Gulf Harbor Estates
Petition Number: 16-4PP

Staff Report

Owner: Southbridge Investments, LLC.

Agent: Tom Ballenger, P.E., GAP Engineering & Planning, LLC

MAP 4: Proposed Gulf Harbor Estates Preliminary Plat

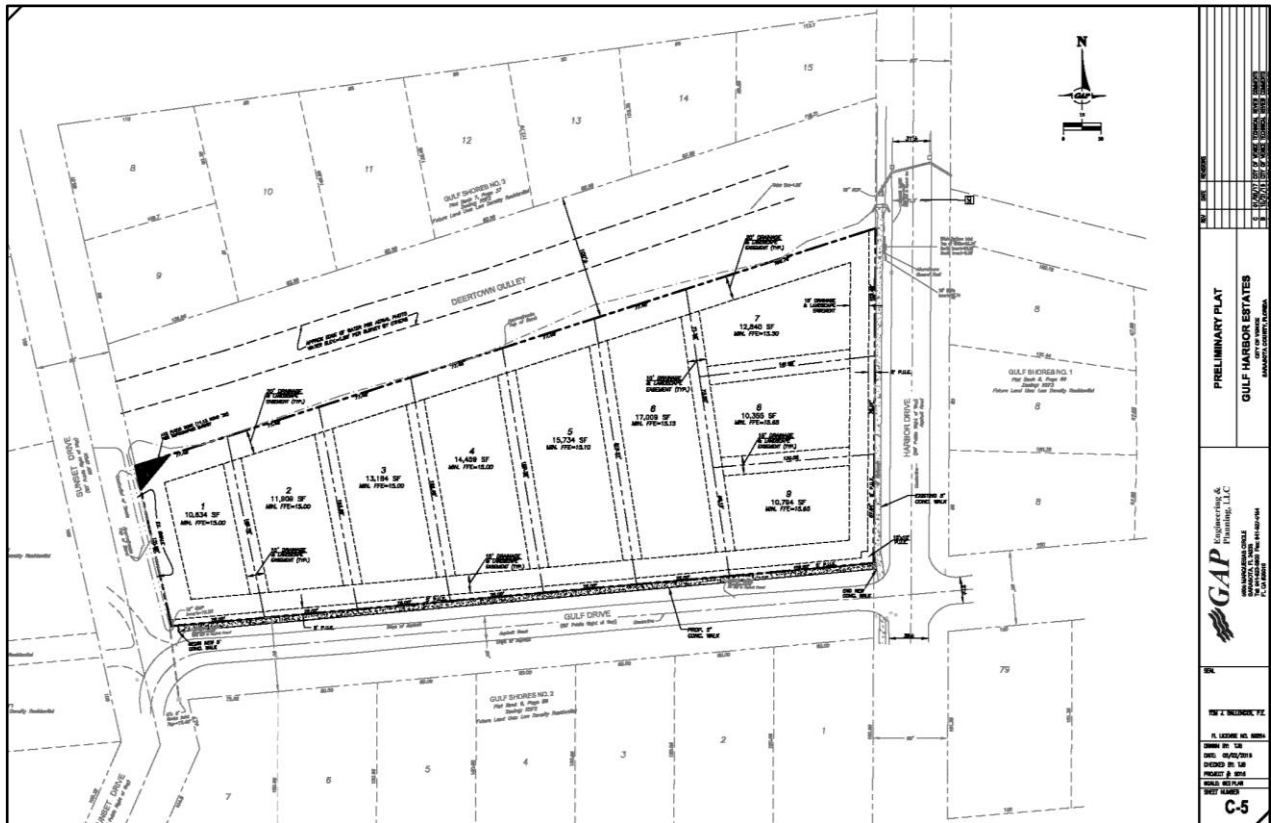
The proposed lots have lot areas that range between 10,355 square feet to 17,009 square feet. The six lots that front only on Gulf Drive have lot widths of 75 feet, while the width of the lots that front on Harbor Drive vary between 79 feet and 102 feet.

No street is proposed as part of the preliminary plat. All of the proposed lots are design to have direct vehicular access to an existing public street. Landscape and drainage easements are proposed on all sides of each lot to accommodate drainage and landscaping improvements. The proposed landscaping satisfies Sarasota County tree replacement requirements. Single family residential uses are exempt from city landscaping requirements.

Proposed off-site improvements include sewer and water connections to mains in Harbor Drive and Gulf Drive right-of-ways and a five-foot wide sidewalk along the west side of Harbor Drive and the north side of Gulf Drive. In accordance with Section 86-520(c), the applicant is requesting a waiver from constructing a sidewalk along a portion of unimproved Sunset Drive.

With the recommended stipulation concerning the effective date of the preliminary plat approval, the proposed preliminary plat was reviewed for compliance with the City of Venice subdivision design standards and the RSF-3 district standards. The Technical Review Committee found the proposed preliminary plat to be in compliance with all but one Land Development Code standard. The one exception is the applicant’s proposal not to provide sidewalks along an unimproved section of Sunset Drive right-of-way required by Section 86-520(a).

In accordance with Section 86-520(c), the applicant has requested a waiver from the construction of approximately 130 feet of sidewalk along the east side of the Sunset Drive right-of-way. Per Section 86-520(c), the Planning Commission may recommend to the City Council a waiver of the sidewalk requirement when the property owner can demonstrate that the required sidewalk will not be reasonably beneficial or useful because of location of the subject property and the characteristics of the immediate neighborhood.

Staff Comment: The subject property is in an existing Sarasota County Residential, Single Family 2 (RSF-2) zoning district. However, the proposed preliminary plat has been reviewed for compliance with City of Venice RSF-3 minimum lot area (7,500 square feet) and minimum lot width (75 feet) standards with an understanding that preliminary plat approval would not be effective until the subject property obtains City of Venice RSF-3 zoning. The proposed lots in the preliminary plat exceed the minimum lot area standard (lots size vary between 10,355 square feet and 17,009 square feet) and the proposed lots are in compliance with the minimum lot width standard.

- 1) The preliminary plat approval shall become effective with adoption of a City of Venice RSF-3 zoning designation for the subject property.

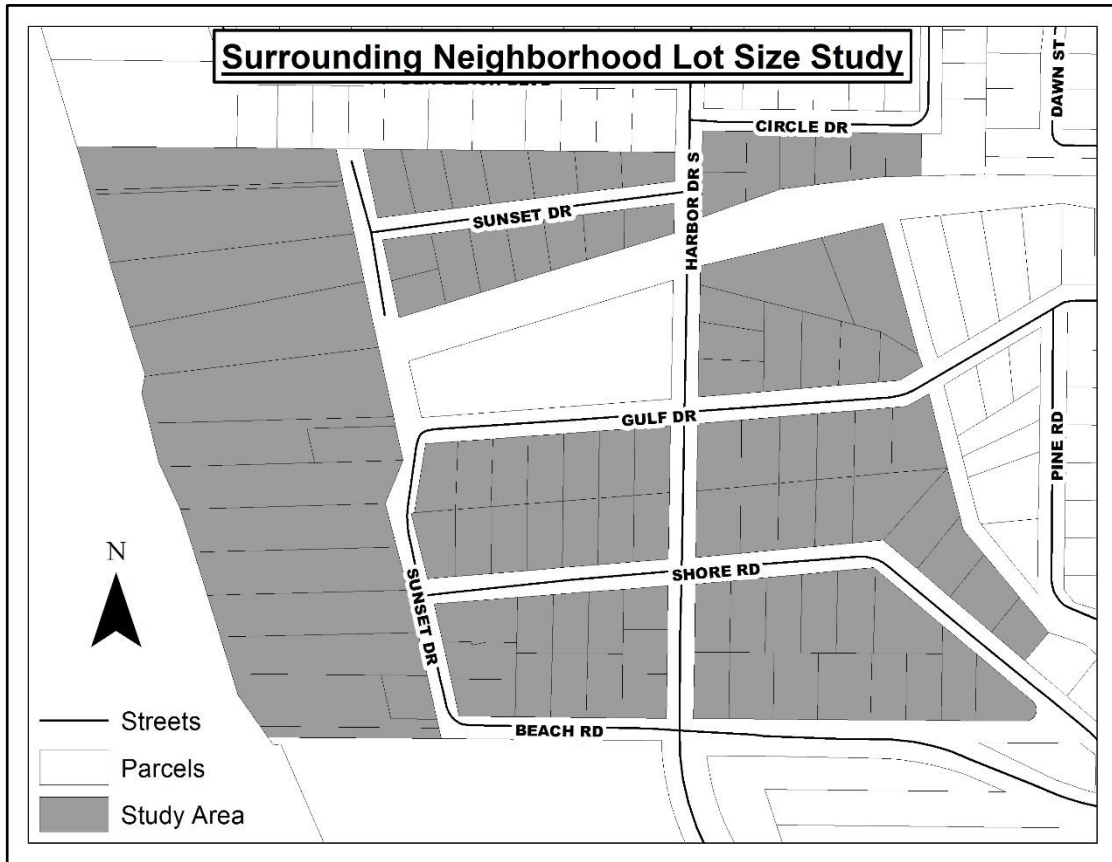
Regarding the second consideration, staff conducted an analysis of Sarasota County Property Appraiser data to compare the proposed residential density to the existing residential density of the surrounding neighborhood. The map on the next page shows the subject property and the surrounding properties that were studied. All of the surrounding properties have either RSF-1, RSF-2 or RSF-3 zoning.

The results of the analysis show that the average lot size of the proposed preliminary plat (12,991 sq. ft.) is approximately 3,400 sq. ft. less than average lot size for the entire study area. However, when the more unique and larger RSF-1 zoned gulf-front properties are excluded from the analysis, the average lot size of the proposed preliminary plat is actually greater than the RSF-2 and RSF-3 zoned portion of the study area (12,639 sq. ft.).
